WELL NAME: Lentini 1 Federal #22

API #: 30-015-28475 CHEVNO: QY4108

### SUPPLEMENTAL WH & CASING REPAIR

**Lentini 1 Federal 22  
30-015-28475  
Chevron U.S.A. Inc.  
July 21, 2014  
Conditions of Approval**

## Chevron U.S.A. Inc. Wellbore Diagram : LNT22

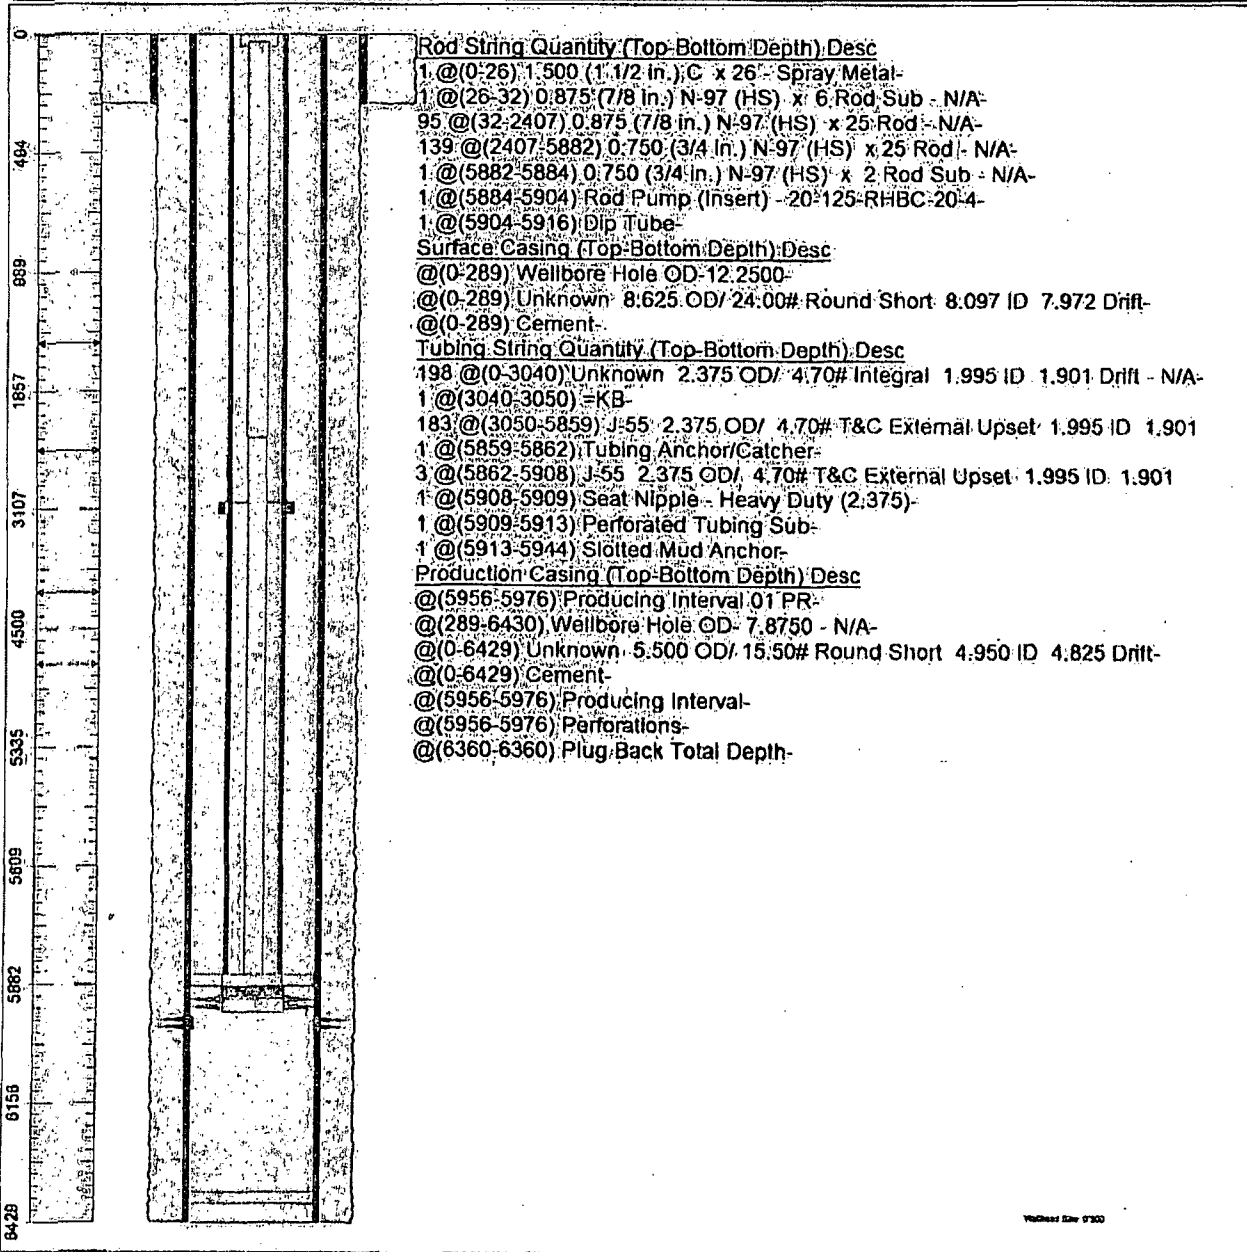
See  
COA

2800 psi
